Ref: FCC Class II Permissive change for FCC ID: HZB-8460
Original Grant date: 10/31/2002
Applicant: Proxim Corporation

This is to request a Class II permissive change for FCC ID: HZB-8460 , originally granted on 10/31/2002

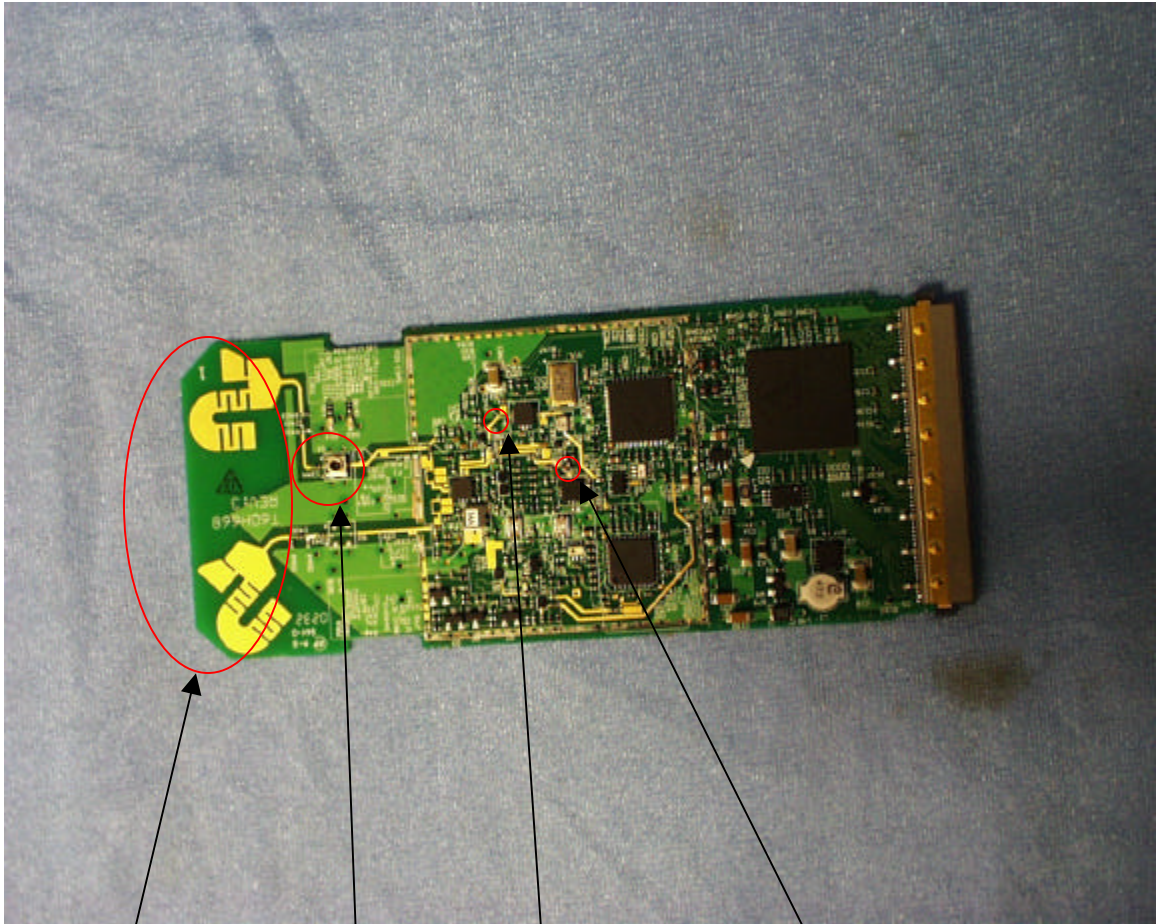
Change 1. The integral antenna was re-designed from a wire type to a printed circuit board antenna.

Change 2. A 0402 inductance 27nH (C342) was added to the power amplifier output to increase the amplifier linearity in the 5 GHz frequency band.

Change 3. A 0402 inductance 1nH (L400) and a 0402 capacitance 1.2pF (C403) was added to the power amplifier output to reduce the second harmonic and improve the mask in the 2.4 GHz frequency band.

Change 4. Change the test port location.
